**DEPARTMENT OF TRANSPORTATION
STATE OF GEORGIA**

Project number: STP-8042(9)

Description: I-185 @ Buena Vista Road Interchange

INITIAL CONCEPT TEAM MEETING
MEETING MINUTES
Buena Vista Road from I-185 to Dogwood Drive
STP-8042(9), P.I. No. 351190, Muscogee County

DRAWING No.
13-02

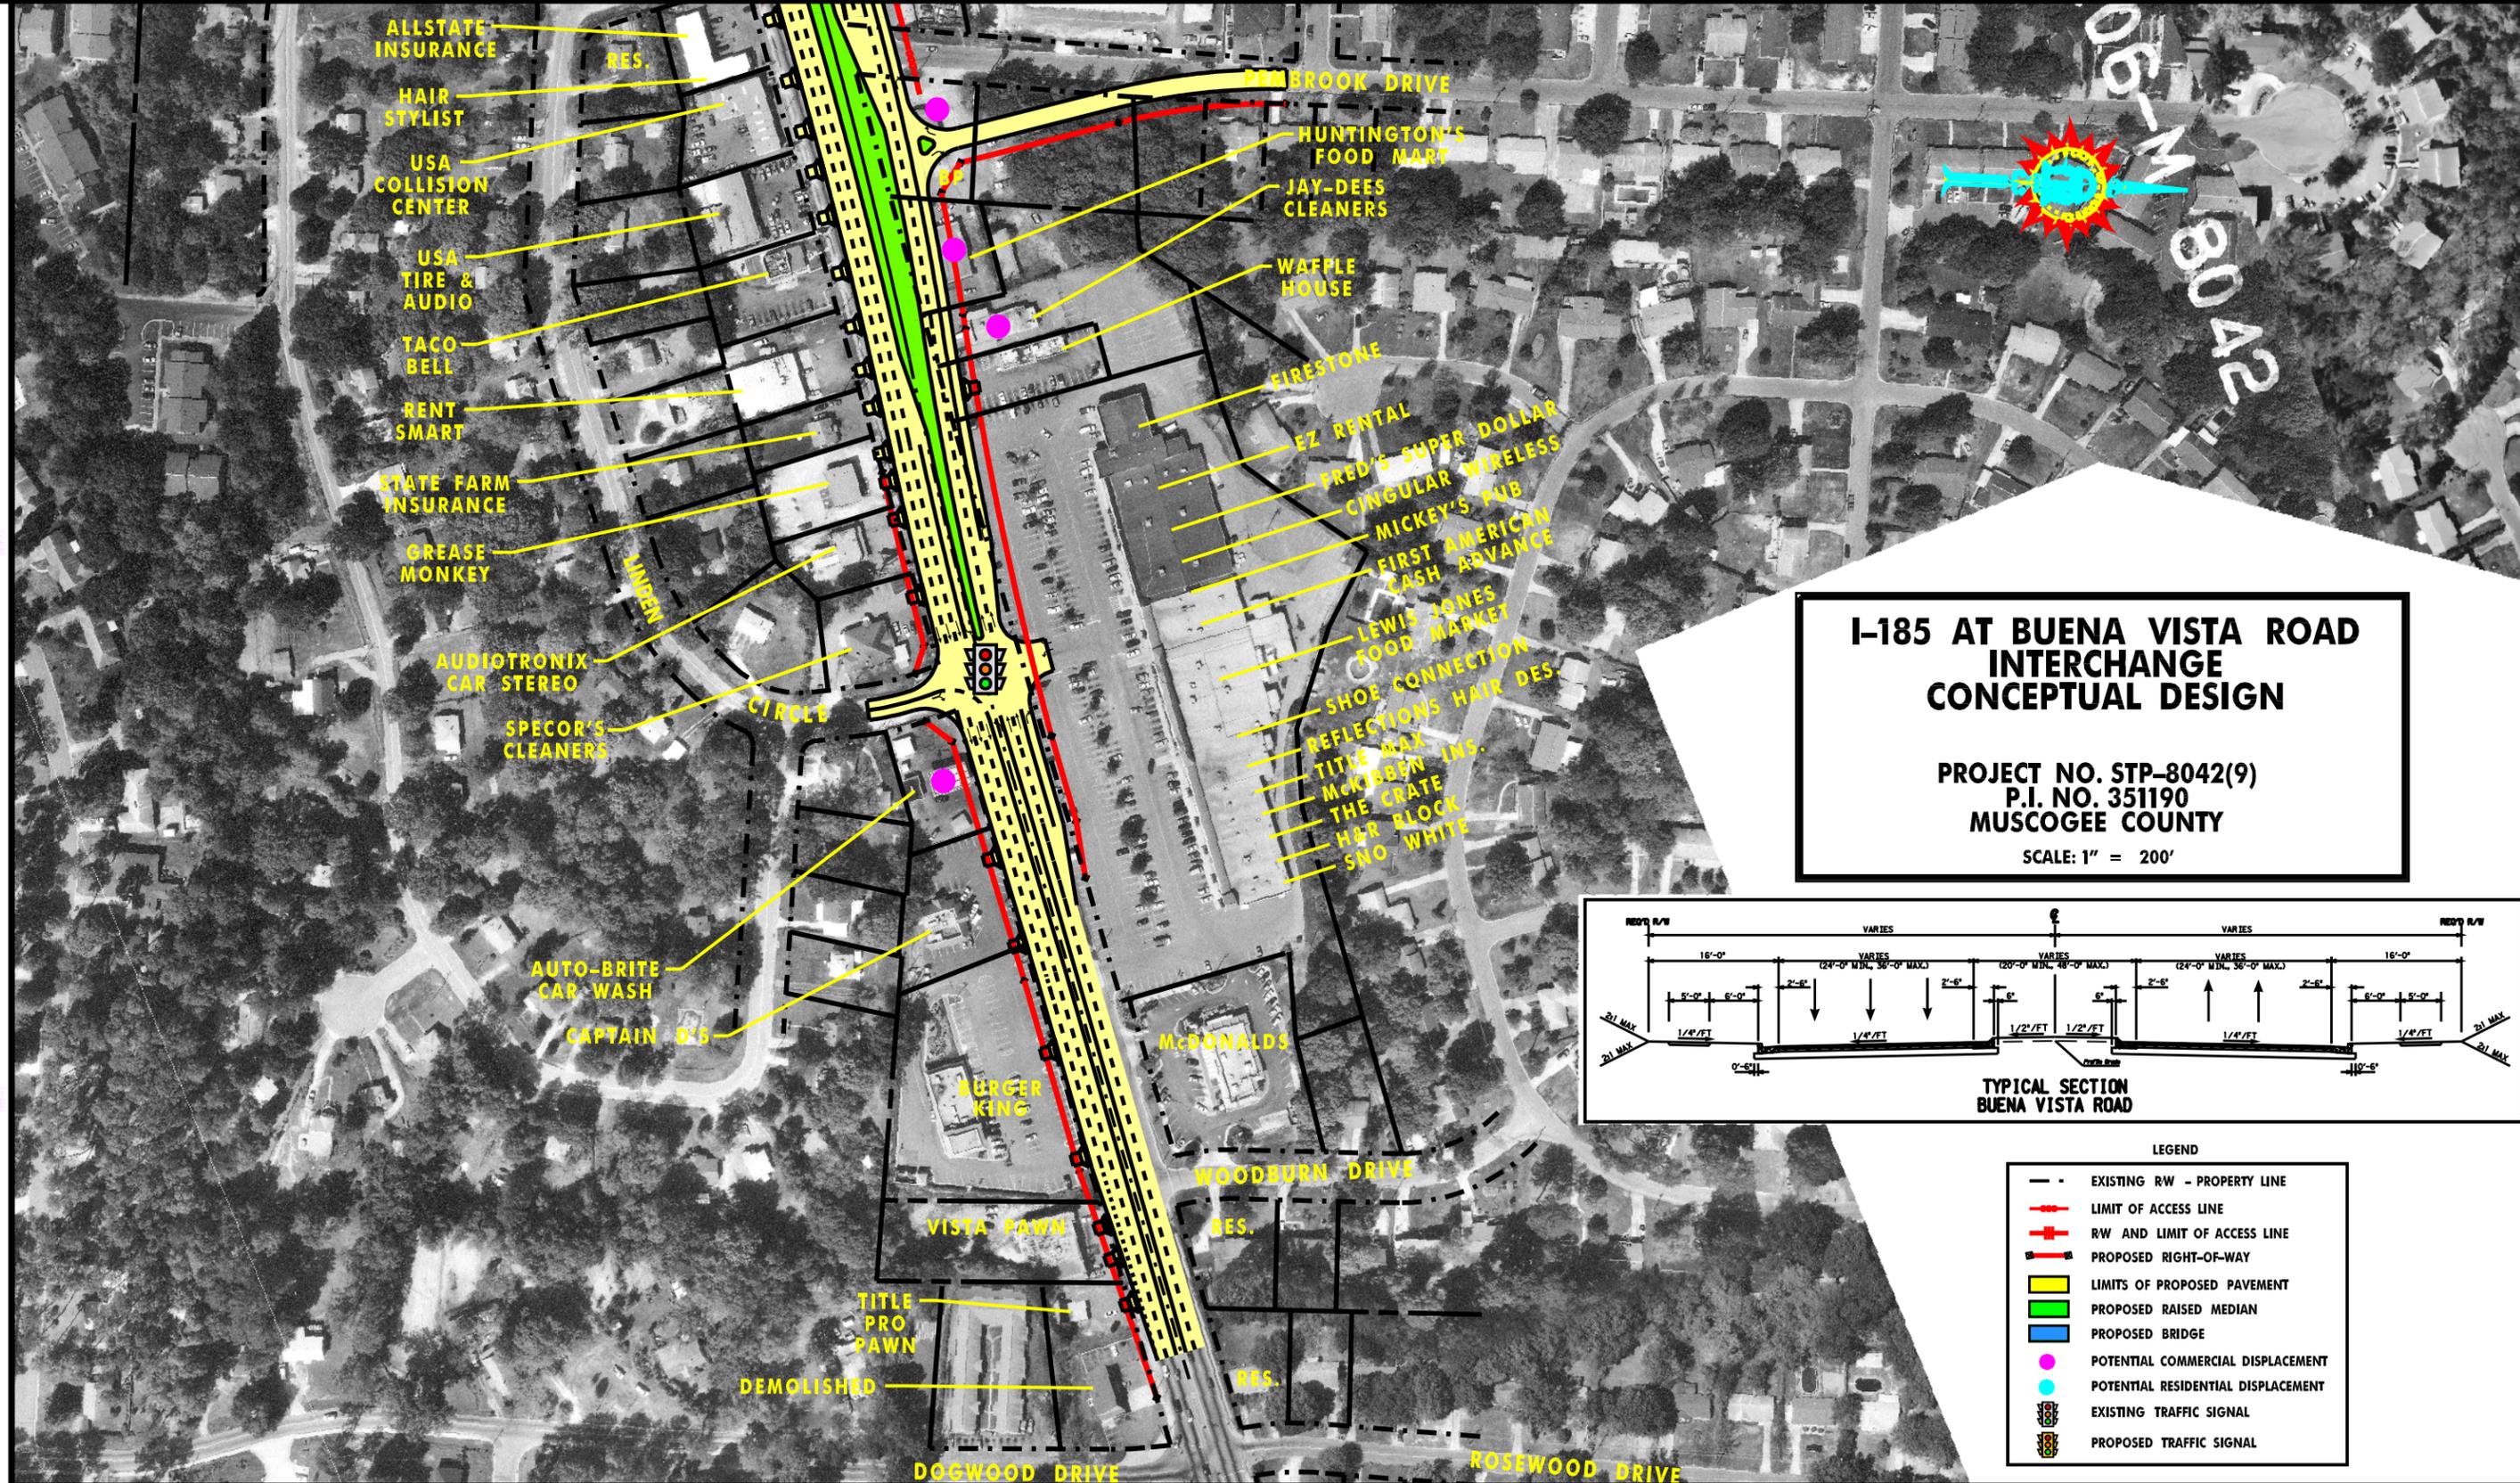
- The proposed traffic signals should be interconnected with underground rather than overhead fiber. There is no local TMC.
- The third EB through lane should be carried through Linden Circle at the Mall Entrance, and then tapered back into the mainline. PBS&J will revise the concept accordingly. The lane taper should be a minimum of 245' long, but longer is desirable.

- Scott Zehngraft of GDOT Traffic Safety and Design questioned the use of dual rights at the intersection of the NB exit ramp with Buena Vista Road. He asked whether a dual left /right center lane would operate more efficiently. PBS&J will verify.

- Scott Zehngraft of GDOT Traffic Safety and Design questioned the proposed storage lengths of turn lanes on the I-185 exit ramps. It was noted that the proposed storage lengths are roughly the same as the existing storage lengths. PBS&J will verify the recommendations. PBS&J will also analyze the storage lengths using HCS in addition to Corsim.

- Scott Zehngraff at the Department also questioned the proposed turn-bay lengths for the exit-ramps and thought that they should be longer. The proposed turn-bay lengths are adequate and result in an acceptable LOS for those approaches under future design hour conditions. Theoretically, there is no problem with lengthening the turn-bay lengths on the exit-ramps (i.e. it would not hurt operations) but there would need to be criteria other than acceptable LOS provided in order to justify that the turn-bays were long enough. The reason that the turn-bay lengths on the ramps were not lengthened is that the improvements on Buena Vista Road will provide more capacity at the intersections with the ramps, eliminating the need to provide more capacity on the exit-ramps themselves. It was also suggested that HCS be used to analyze storage bay lengths. HCS does not model turn-bay lengths. HCS only takes into consideration that there is a turn-bay but it does not care how long the turn-bay is. Moreover, HCS, or any other non-simulation program, would not be capable of analyzing the proper traffic operations of closely spaced intersections such as these two intersections with the I-185 exit ramps. CORSIM is best suited to analyze the traffic operations of such a situation.
